**TOWN OF NEWBURGH
PLANNING BOARD
TECHNICAL REVIEW COMMENTS**

PROJECT: 3 RIDGEVIEW DRIVE SUBDIVISION
PROJECT NO.: 15-34
PROJECT LOCATION: SECTION 98, BLOCK 1, LOT 14.13
REVIEW DATE: 29 APRIL 2016
MEETING DATE: 5 MAY 2016
PROJECT REPRESENTATIVE: WILLINGHAM ENGINEERING

Re: **PB Project #: 2015-34**
3 Ridgeview Drive Subdivision
2 – Lot Subdivision
Town of Newburgh
Minor Subdivision Application

SUBDIVISION PLAT

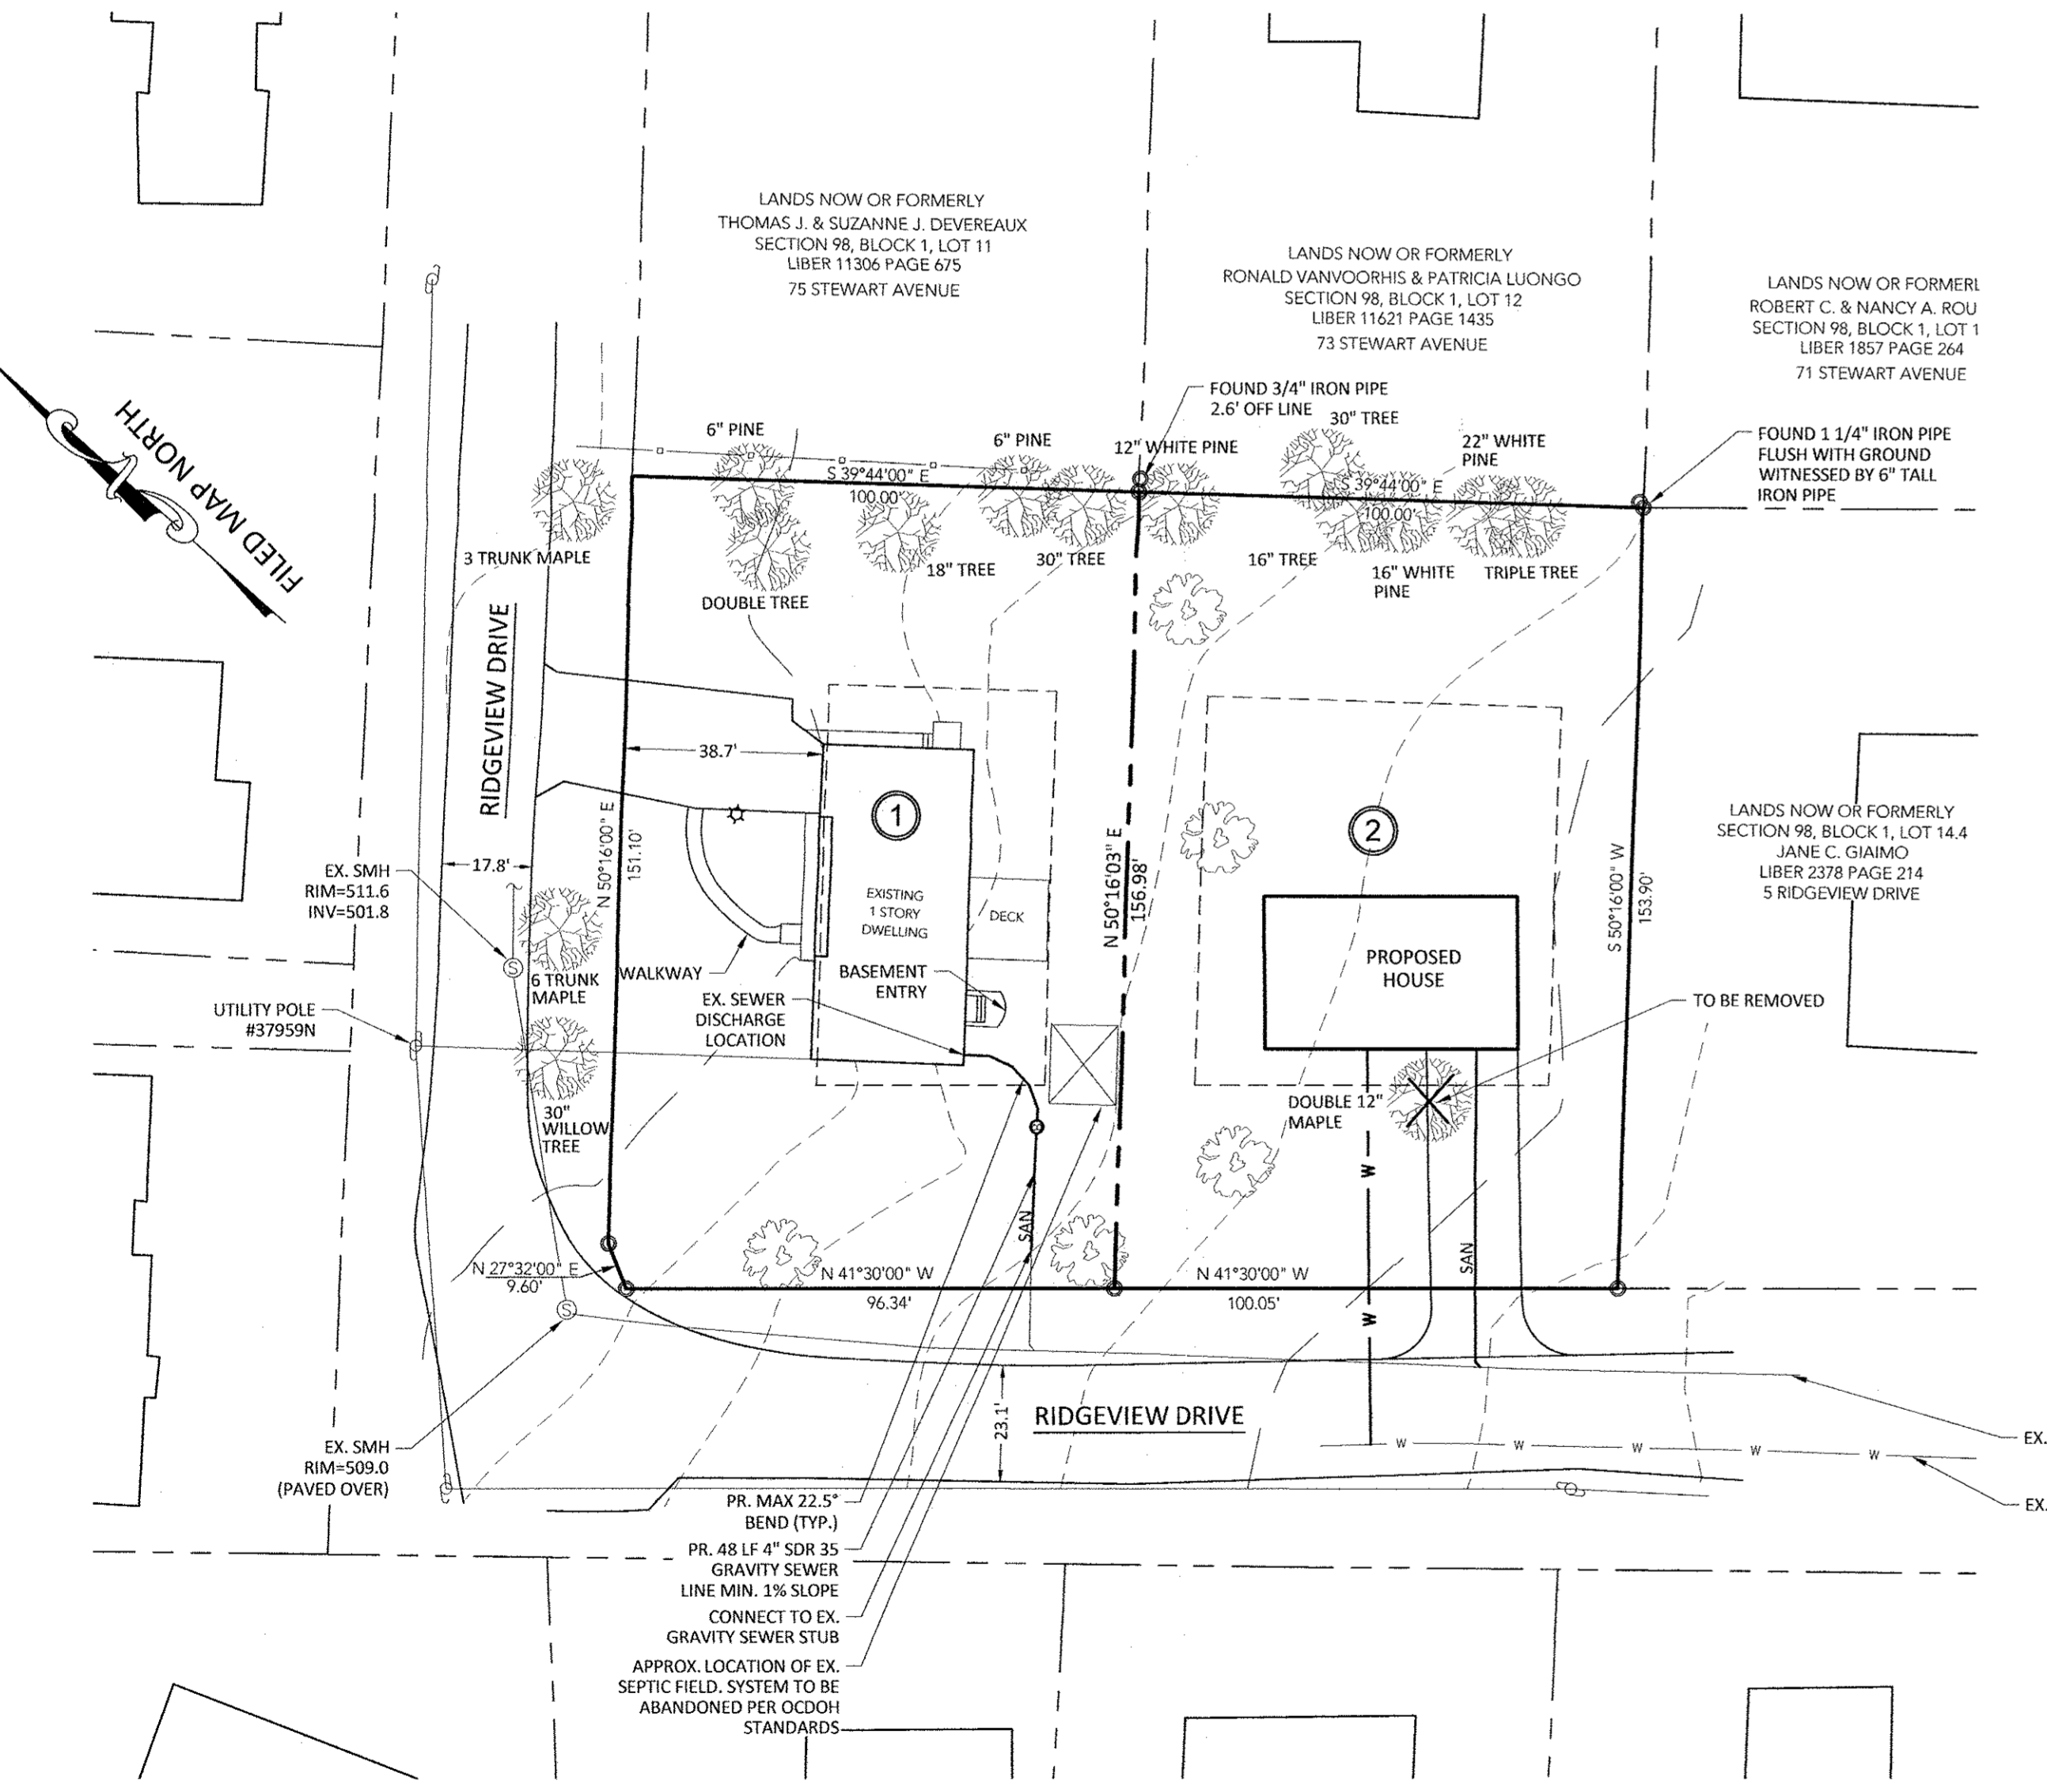
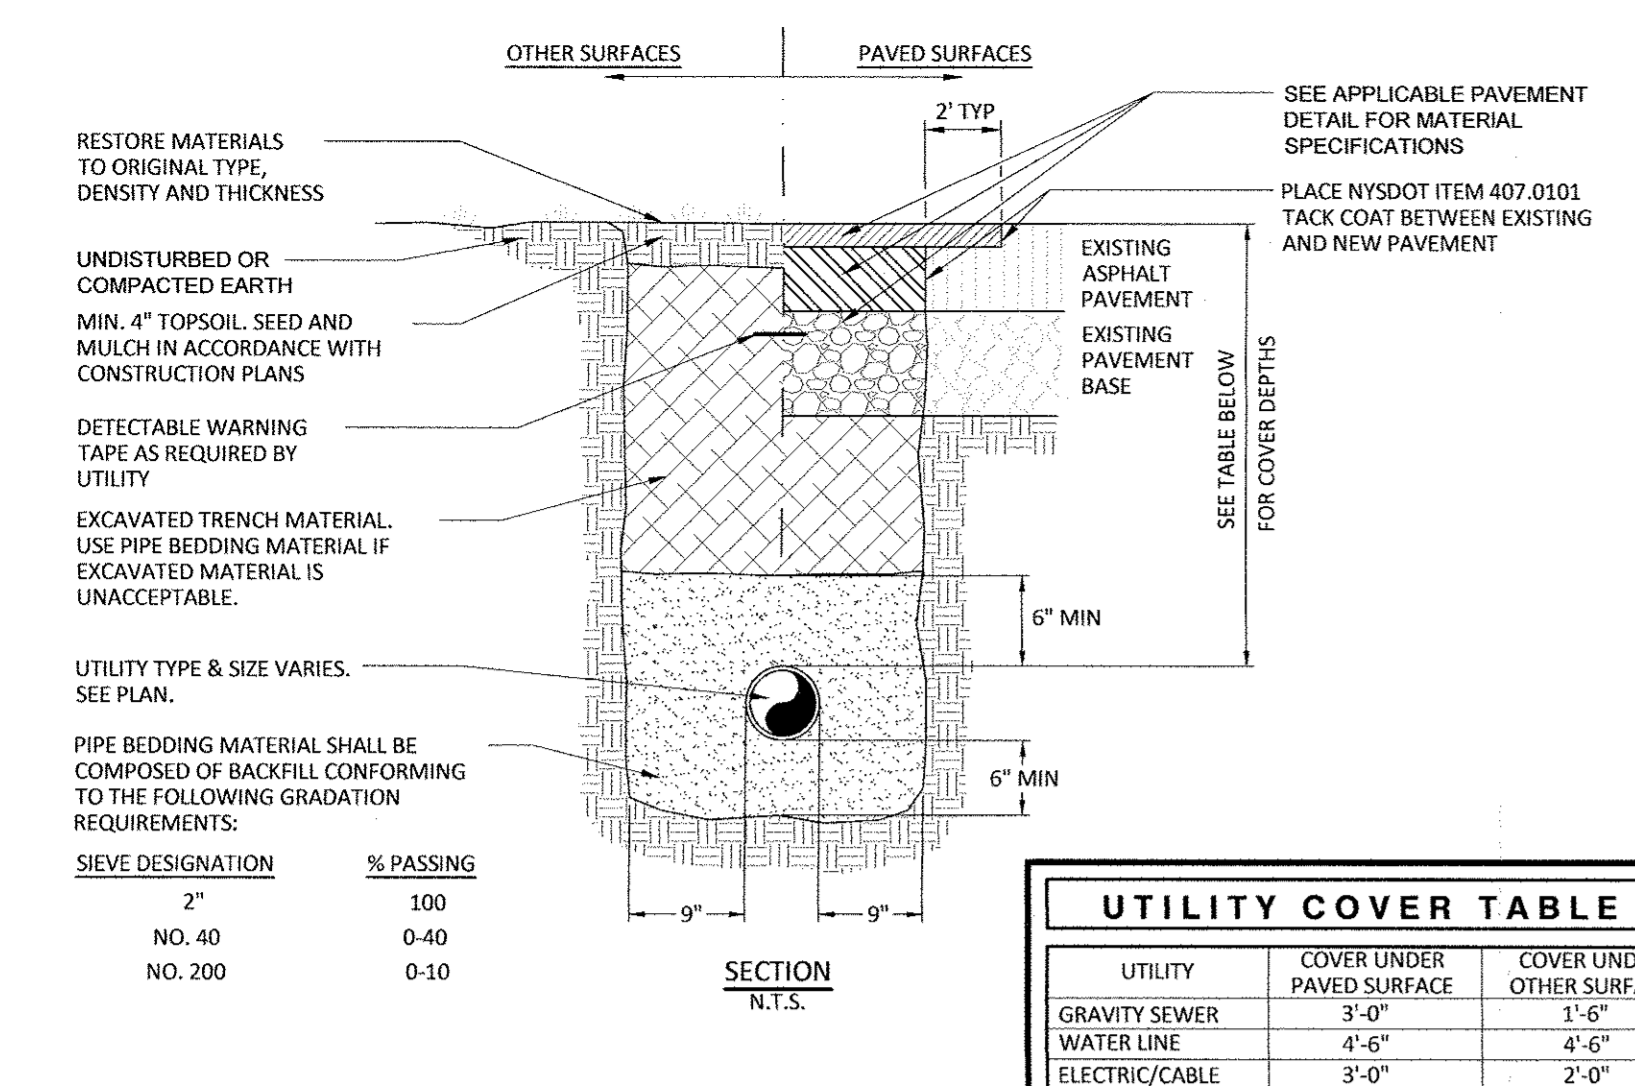
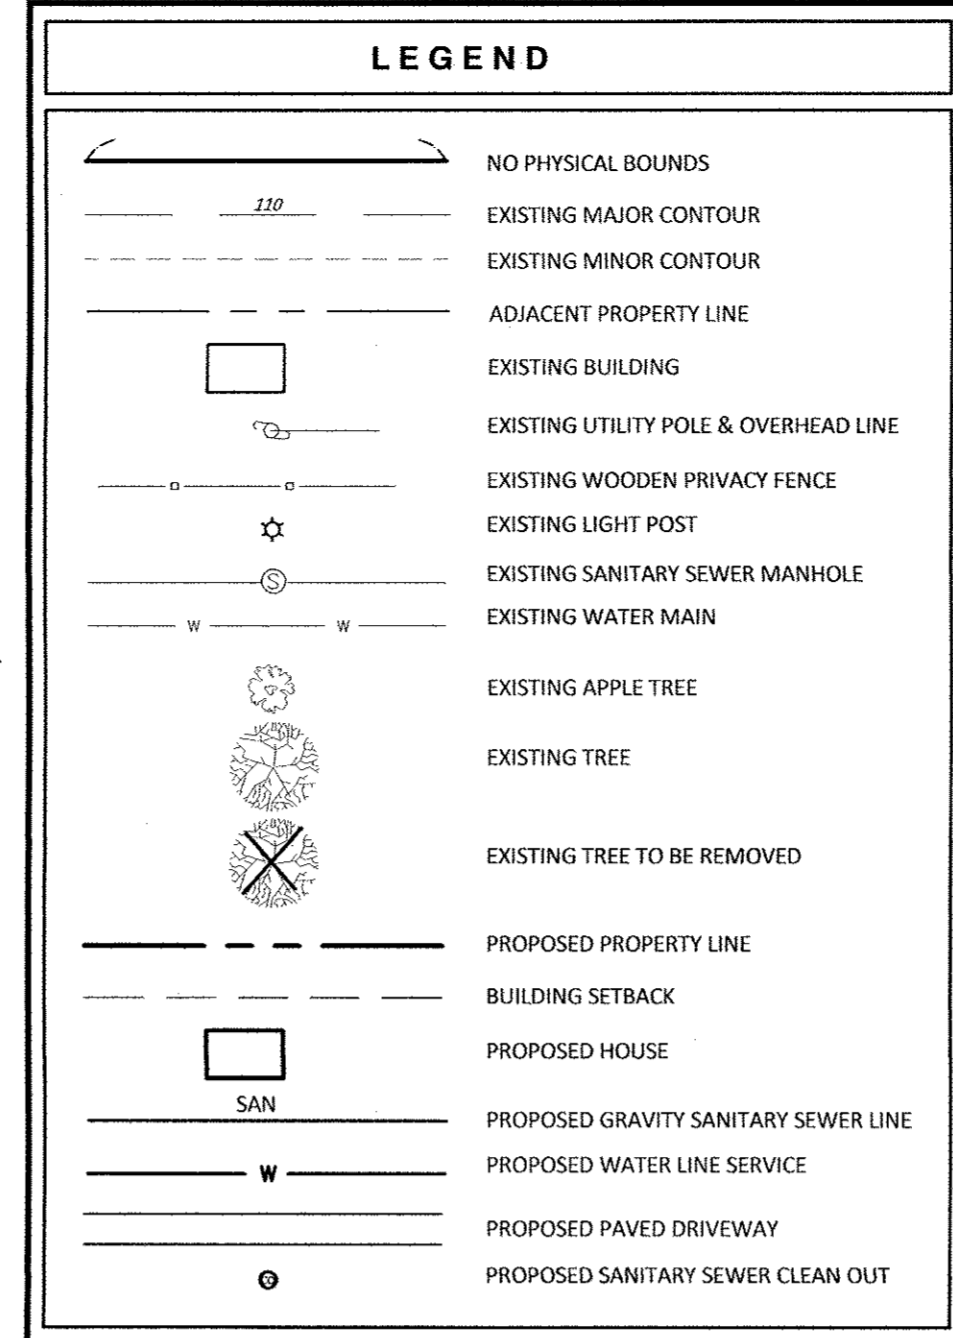
1. The project has received ZBA variances for the existing encroachments on proposed Lot #1.
2. The project has identified that Lot #1, the parent parcel, is served by a subsurface sanitary sewer disposal system. It is now proposed that the lot connect to the Town of Newburgh Sanitary Sewer Collection System. A revised City of Newburgh Flow Acceptance letter for 2 houses must be received based on hydraulic loading from the residential structures.
3. A Public Hearing is required.
4. Town of Newburgh water and sewer notes have been added to the plans as previously requested.
5. Finished floor elevations for existing and proposed structures should be identified on the plans. Finished floor elevations should be coordinated with lowest sewerable elevations to conform that gravity flow to the sanitary sewer lines is available.

1. Willingham Engineering and the Applicant appeared before the Zoning Board of Appeals on March 24, 2016 and received an area variance for the non-conforming front yard setback on proposed Lot 1.

2. The 'Lot Area Summary' table has been revised to indicate that the project is located within the R-3 zone.
3. Please see the attached Memorandum from the Highway Department dated April 21, 2016. We have also added additional details on the driveway (see comment 7 below).

4. A note has been added to the plans indicating that a stake out of the proposed house is required to be submitted to the building department prior to construction. We also moved the proposed house location more than 5 feet from the side yard setback further prevent any noncompliance issues.

5. Ridgeview Drive is not a private road, therefore 'Map Notes' item 7 has been removed from the plan.
6. Updated water and sewer notes have been added to the plans. Details relating to the proposed driveway have also been added.

7. Drainage at the proposed driveway has been addressed in the driveway details. Ridgeview Drive does not have roadside ditches, driveway culverts or a stormwater collection system. We are proposing a depression at the driveway entrance to convey drainage off of Ridgeview Drive and southeast, maintaining the current drainage pattern. A pavement replacement detail has been added to the plan for the utility connections.

We also note a revision regarding the existing septic discharge on the lot. We've come to understand that the central sewer system along Ridgeview Drive was installed after the Subdivision was constructed. Many homeowners connected to the system, however the home at 3 Ridgeview Drive did not. The approximate location of the existing septic system is shown on the plan. The existing system will be abandoned in accordance with Orange County Health Department standards and the existing home will be connected to the sewer main. The location of the existing sewer stub is shown on the plan (notes on the sewer stub location were recorded during installation and provided by a neighbor of Ms. McDonald).
